## CLS-M Series iQube2® Forklift Junction Box

# Software Update – Versions 2.08 & 2.09

**Product:** CLS-M Series iQube2 Forklift Junction Box – PN 164071 and 167340 (red junction box)

Figure 1. Firmware Update Cable Connection

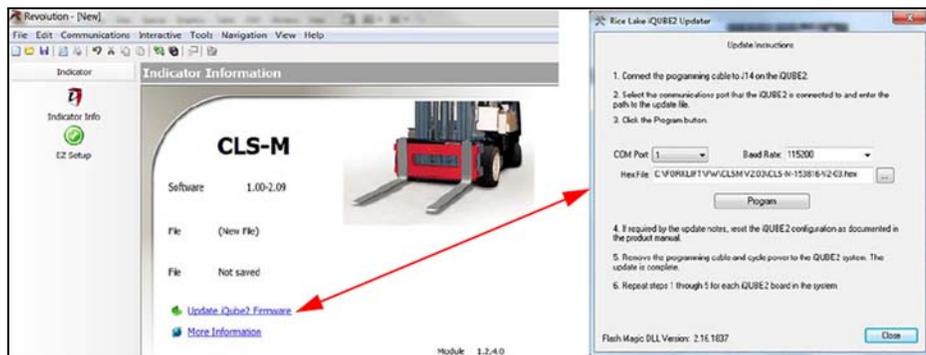
During annual calibrations and repairs, update the CLS-M Series iQube2 forklift junction box using the latest version of Revolution and a USB A to Micro-A cable (Rice Lake PN 152434).
